**SECOND AMENDMENT TO
SUBDIVISION DEVELOPMENT AND IMPROVEMENT AGREEMENT
FOR
TOWN OF JOHNSTOWN
(Johnstown Farms Filing No. 3)**

SCHEDULE 3
Depiction of Excluded Portion of Sidewalk

SCHEDULE 2
Depiction of Sidewalk

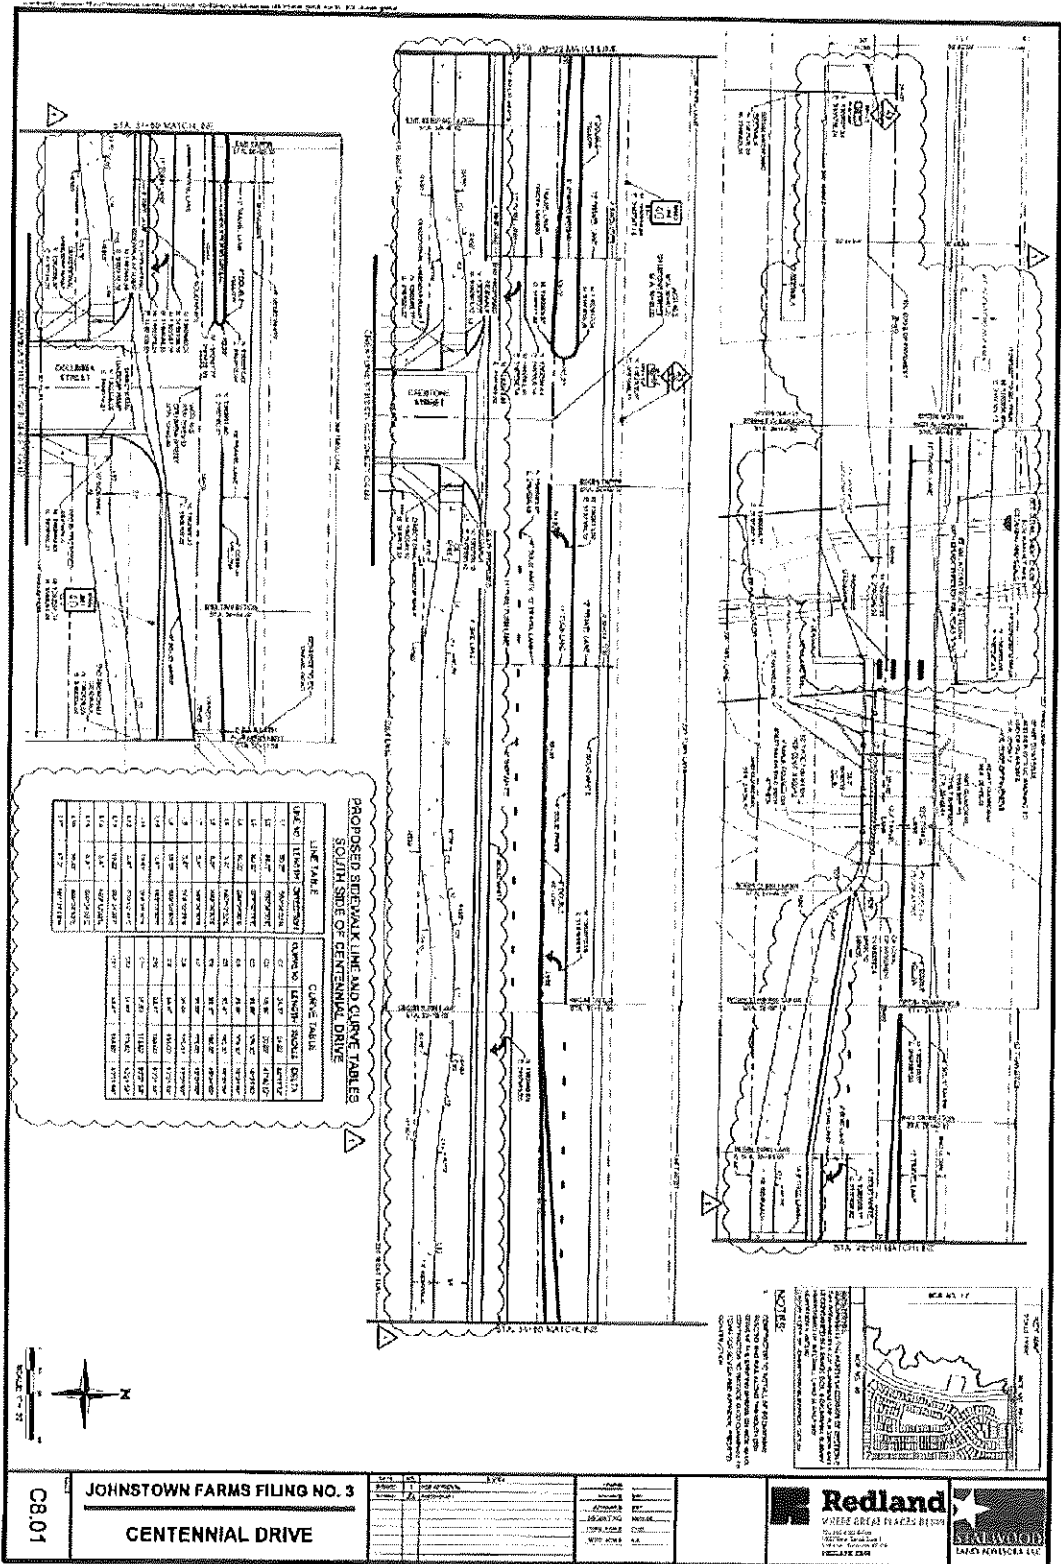
7. Regional Sidewalk Connectivity. Connectivity of a regional trail system is a priority for the Town and, accordingly, the Developer shall construct as a part of the Public Improvements, in accordance with the *revised* approved Civil Engineering Construction Plans, a sidewalk along a portion of the southern one-half of the Weld County Road 46 ½ adjacent to the Property and along a portion of the northern one-half of Weld County Road 46 ½ as depicted in Schedule 2 attached to this Exhibit B-3 (“**WCR 46 ½ Sidewalk**”), except that Developer shall not be obligated to construct the portion of the WCR 46 ½ Sidewalk that crosses the bridge over the Little Thompson River or the portion that is west of the bridge, as depicted in Schedule 3 attached to this Exhibit B-3, nor shall Developer be required to add the cross-walk striping on Weld County Road 46 ½, but shall pay the Town a cash fee in the amount of \$28,033.00 in lieu of such construction and striping. The Town, at its sole expense, shall promptly repair any damage to the WCR 46 ½ Sidewalk resulting from the Town’s Weld County Road 46 ½ roadway and bridge construction. Notwithstanding any contrary provision of this Paragraph 7, the Town and Developer acknowledge that the portion of WCR 46 ½ Sidewalk crossing the railroad right-of-way adjacent to the Development shall require the approval of Great Western Railroad, as the owner of the railroad right-of-way (the “**Railroad ROW**”), and the entering into of a *Public Roadway Crossing License* or similar such agreement (a “**License Agreement**”) by the Town and Great Western Railroad. The Town and the Developer anticipate that the License Agreement shall require the payment to Great Western Railroad of: (i) an initial application fee and (ii) annual license fees or a lump sum license fee. The Developer represents the Developer has paid the initial application fee to Great Western Railroad. If the License Agreement requires an annual license fee, Developer shall pay the first annual license fee and all subsequent annual licenses fees as required under the License Agreement until the Town provides notice of Initial Acceptance of the WCR 46 ½ Sidewalk, after which time the Town shall pay the annual license fee. If the License Agreement requires a lump sum license fee, Developer shall pay a contribution to the Town for such lump sum fee in the amount of \$6,000 not later than thirty (30) after the Town’s written request therefor to Developer. The Town hereby agrees that the Developer’s payment of the initial application fee and license fees, as provided herein, shall fully satisfy Developer’s and the Subject Property’s obligations to make such payments under the License Agreement.

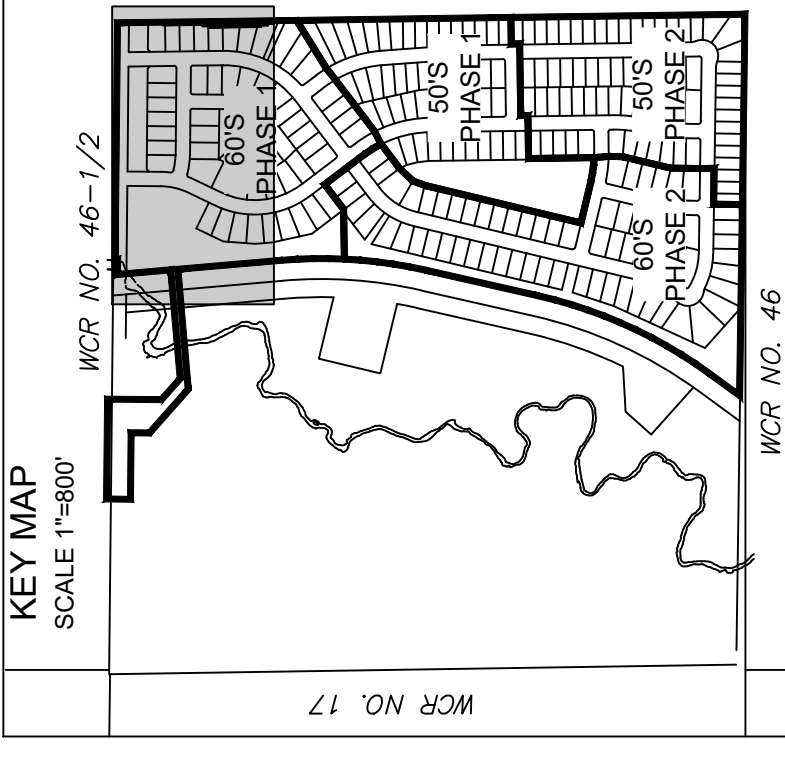
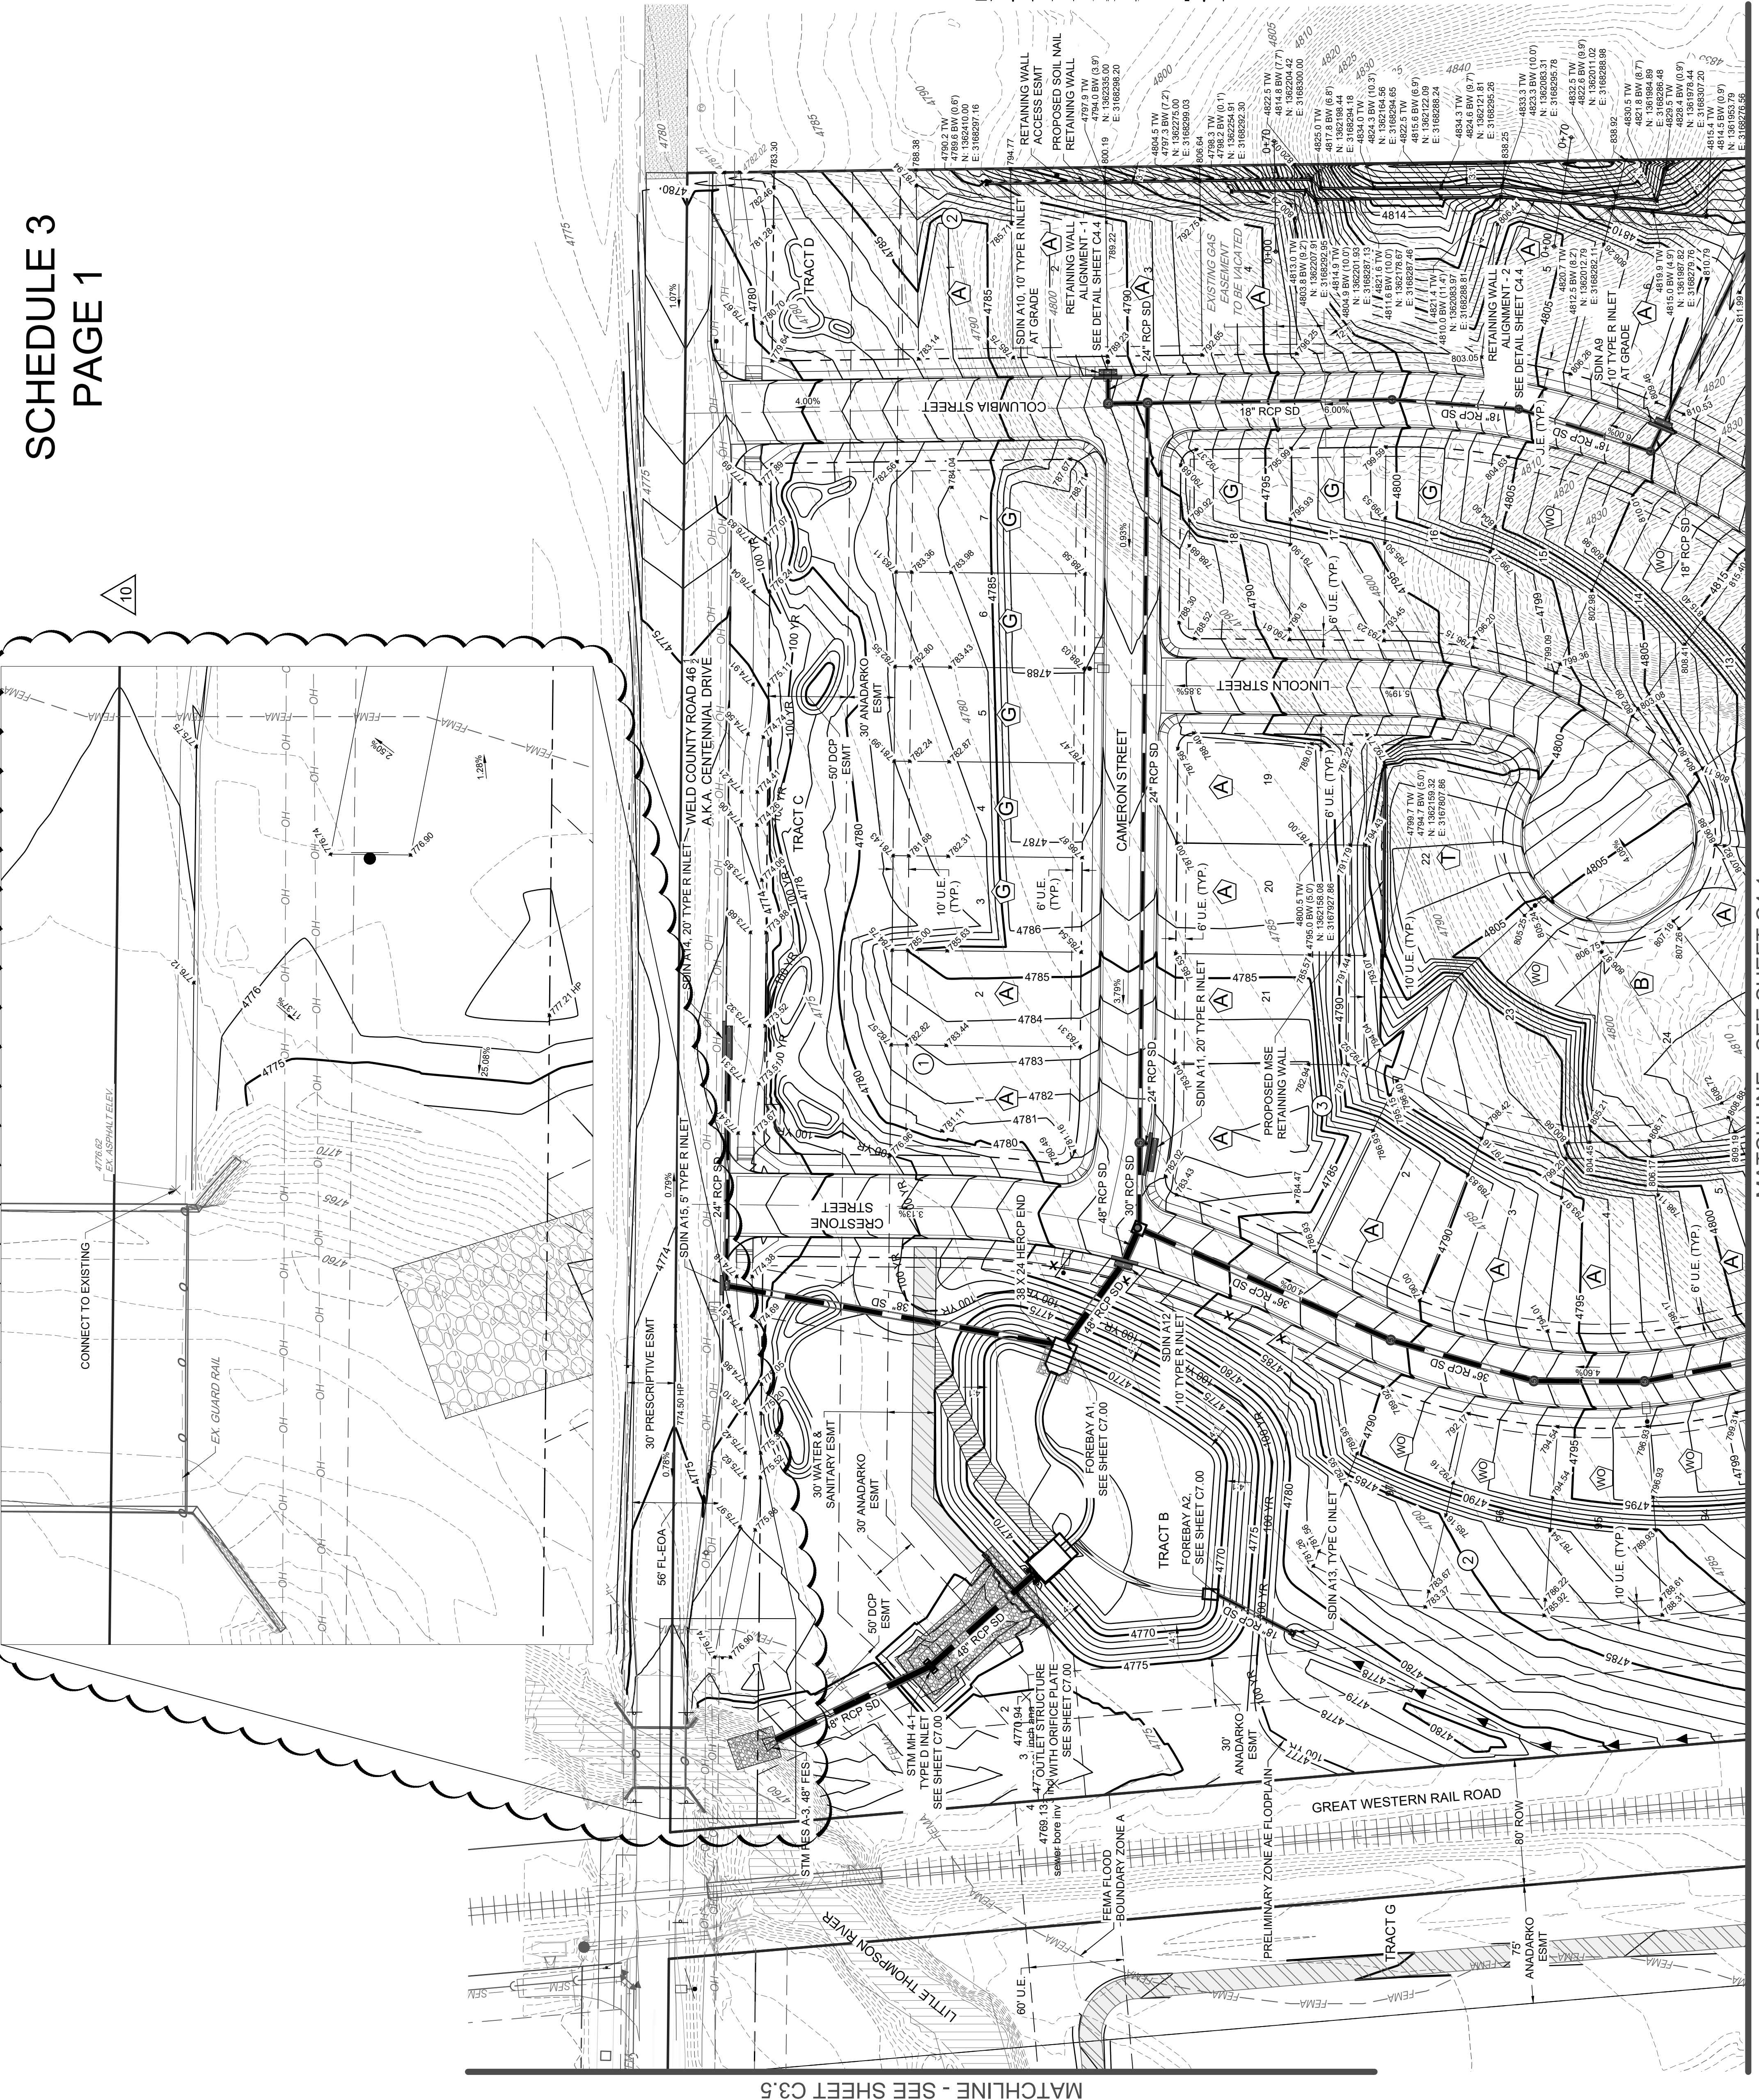
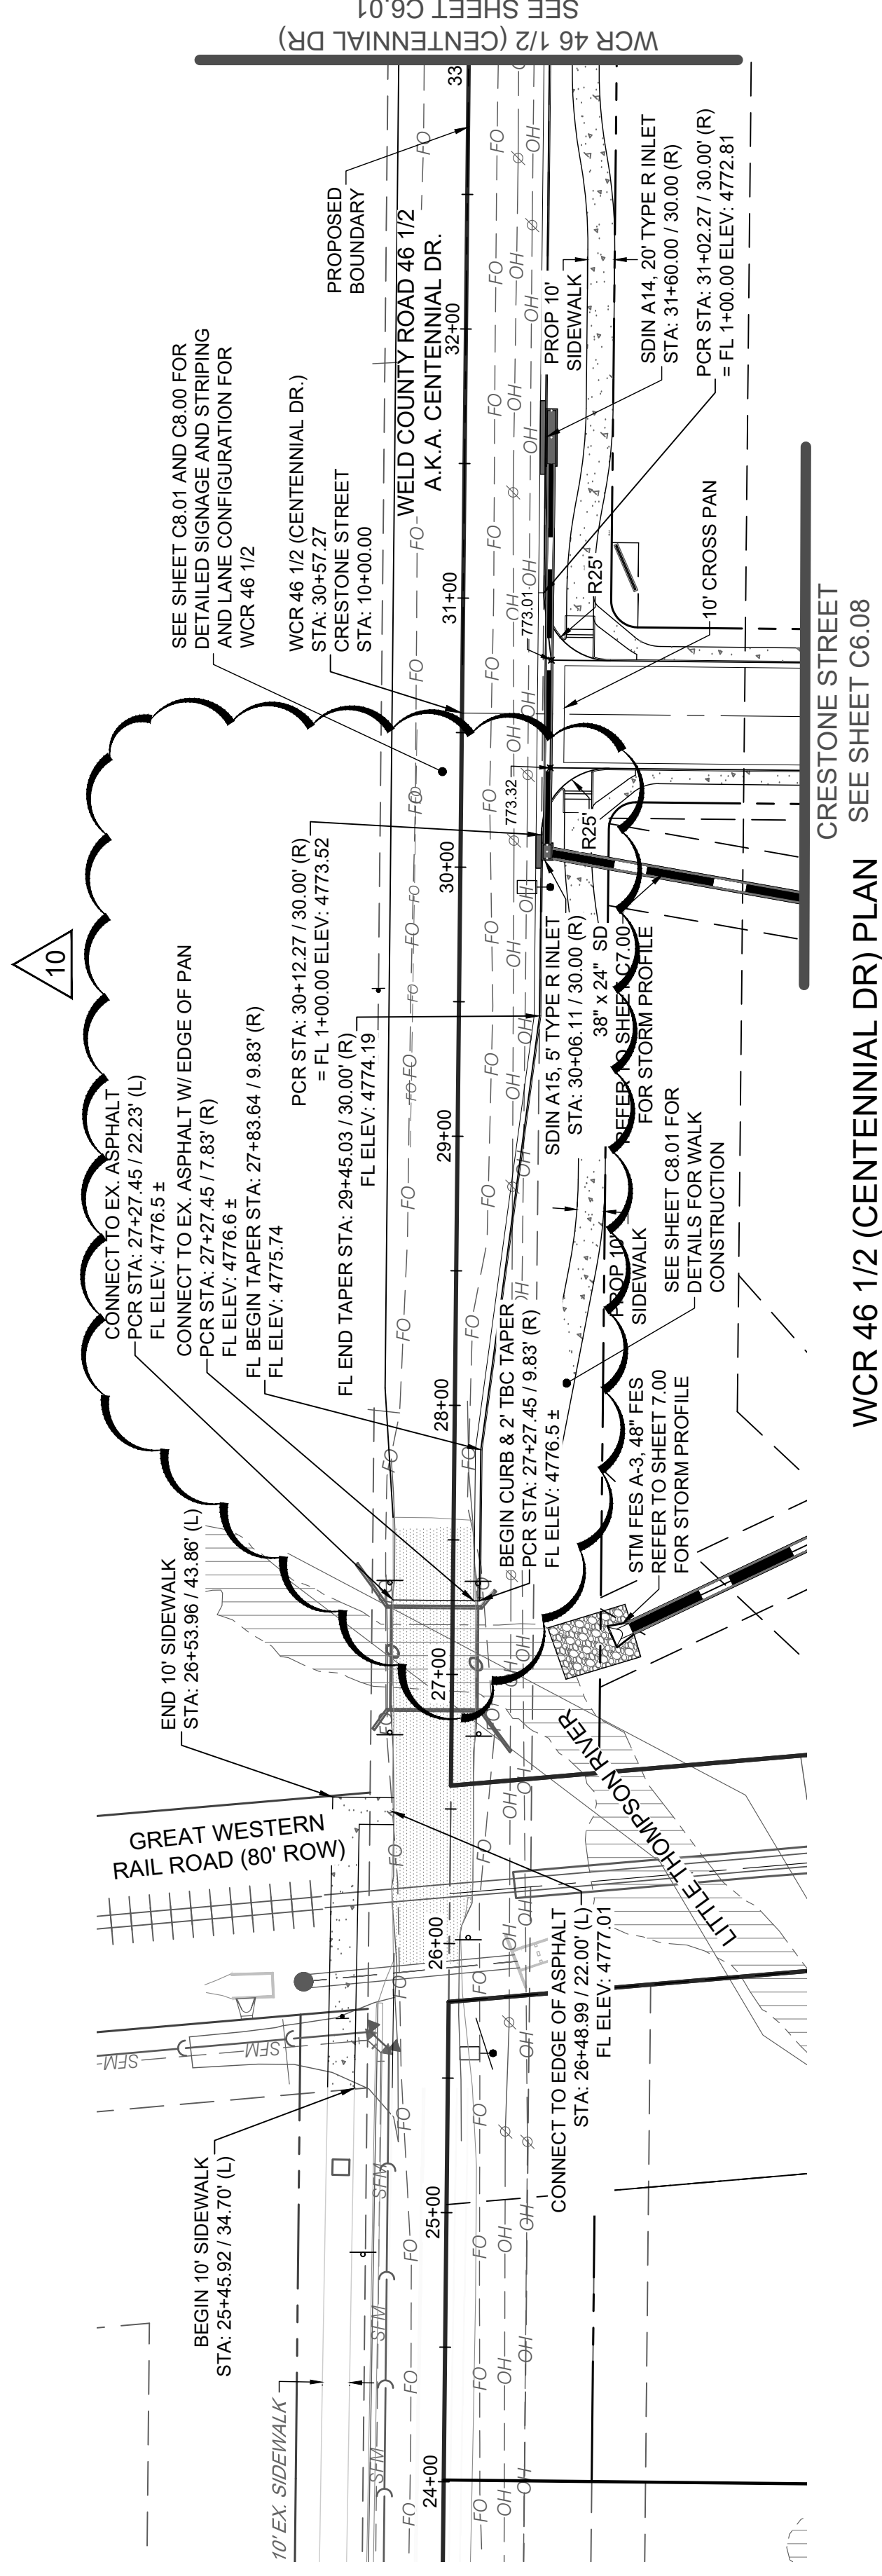
WHEREAS, the Town has determined that it is not feasible or warranted for the Developer to construct the portion of the WCR 46 ½ Sidewalk, as hereinafter defined, that crosses the bridge over the Little Thompson River or the portion that is west of the bridge and that, rather than construction, Developer should pay the Town a cash-in-lieu fee for such portion of the WCR 46 ½ Sidewalk and for the striping of the cross-walk; and
